Well Name: FULLER 14/11 W1FC FED COM	Well Location: T26S / R29E / SEC 14 / NWSE /	County or Parish/State:
Well Number: 3H	Type of Well: CONVENTIONAL GAS WELL	Allottee or Tribe Name:
Lease Number: NMNM11038	Unit or CA Name:	Unit or CA Number:
US Well Number: 3001549318	Well Status: Approved Application for Permit to Drill	Operator: MEWBOURNE OIL COMPANY

Notice of Intent

Procedure Description: Mewbourne Oil Company requests that the following changes be made to Fuller 14/23 W1KN Fed Com #3H well: 1. Well name change to Fuller 14/11 W1FC Fed Com #3H. 2. BHL change to 330' FNL & 2570' FWL in Sec 11, T26S, R29E 3. Changes to directional design plot & plan corresponding to BHL change are included in sundry attachments. 4. Changes to csg program & cmt program corresponding to BHL change are included in this sundry request on page 3 & 4.

Fuller 14/11 W1FC Fed Com #3H

Planning Report

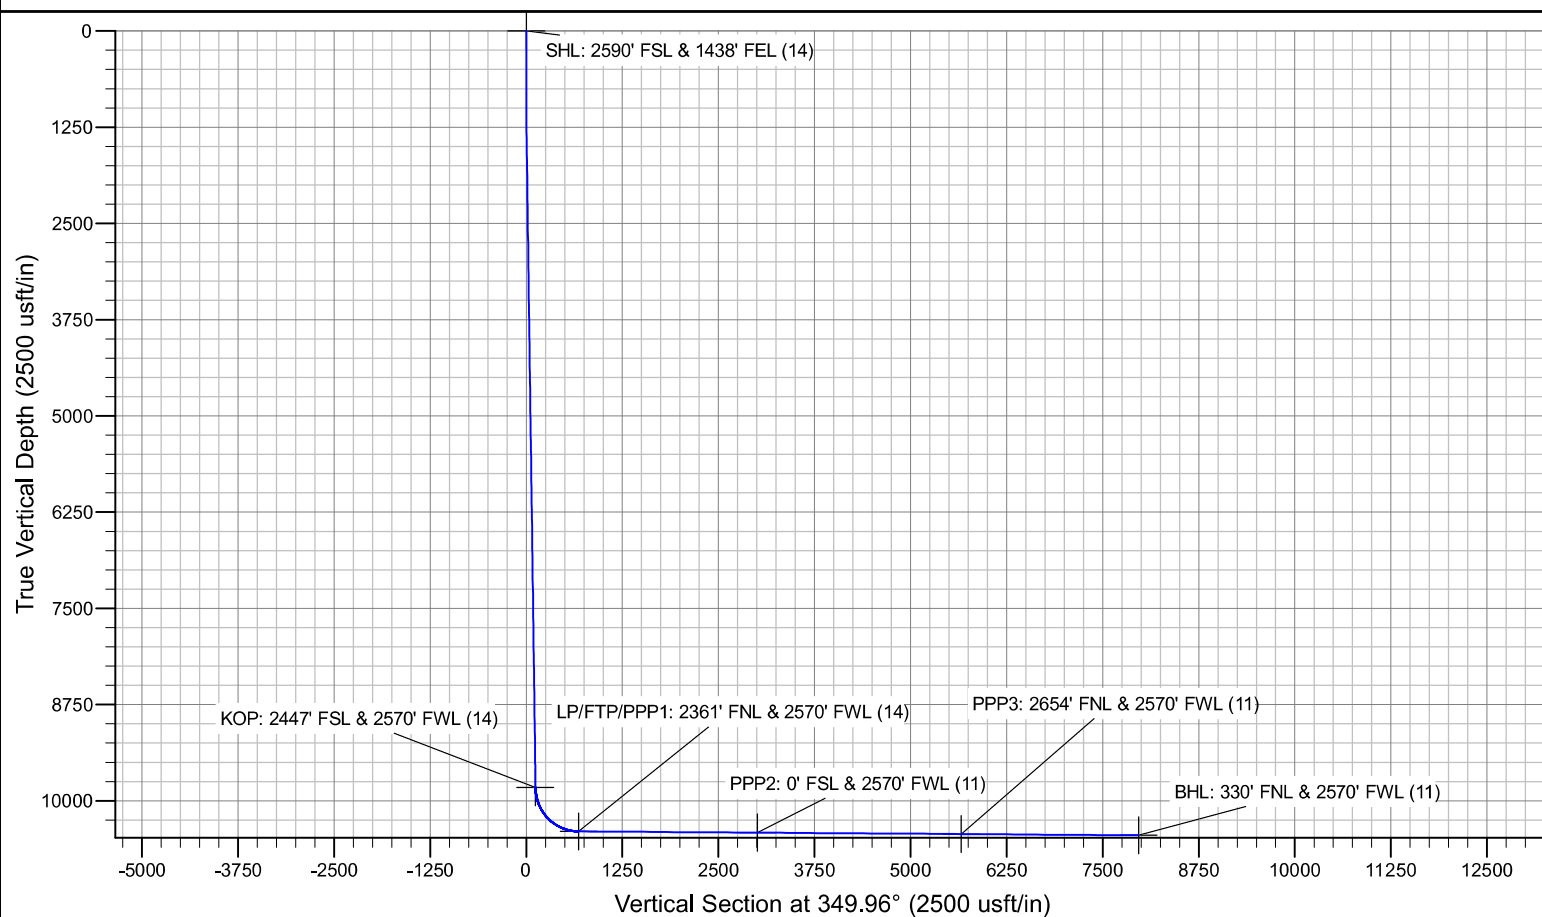
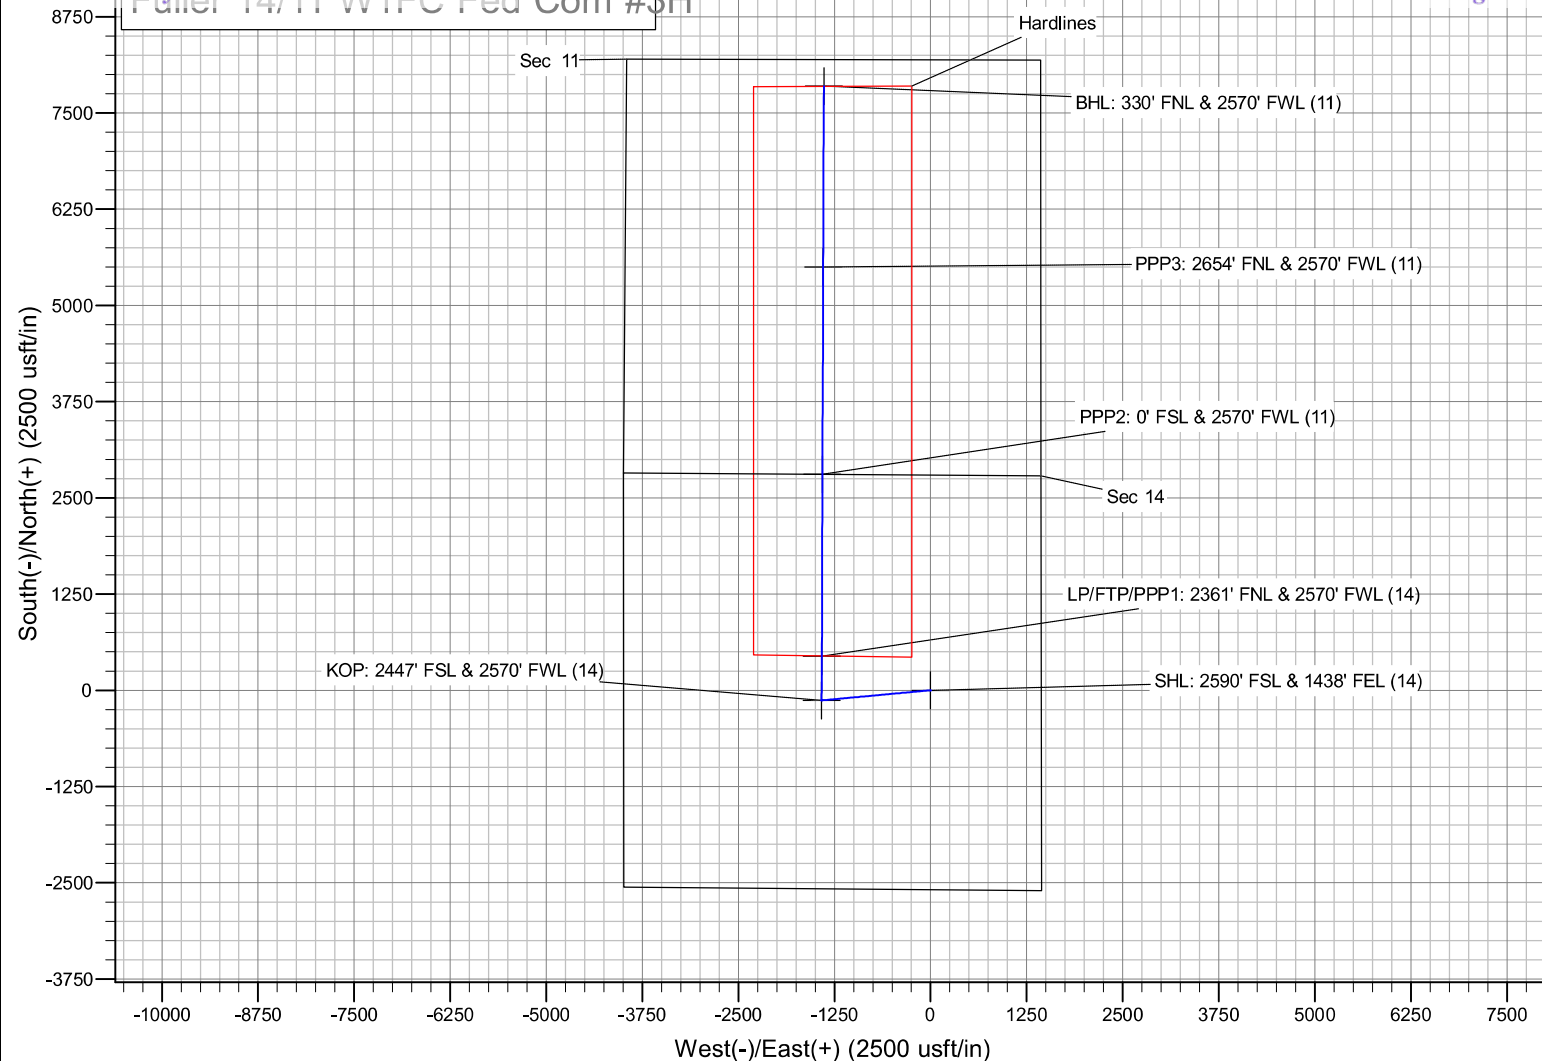
1. Well name change to Fuller 14/11 W1FC Fed Com #3H.
2. BHL change to 330' FNL & 2570' FWL in Sec 11, T26S, R29E
3. Changes to directional design plot & plan corresponding to BHL change are included in sundry attachments.
4. Changes to csg program & cmt program corresponding to BHL change are included in this sundry request on page 3 & 4.
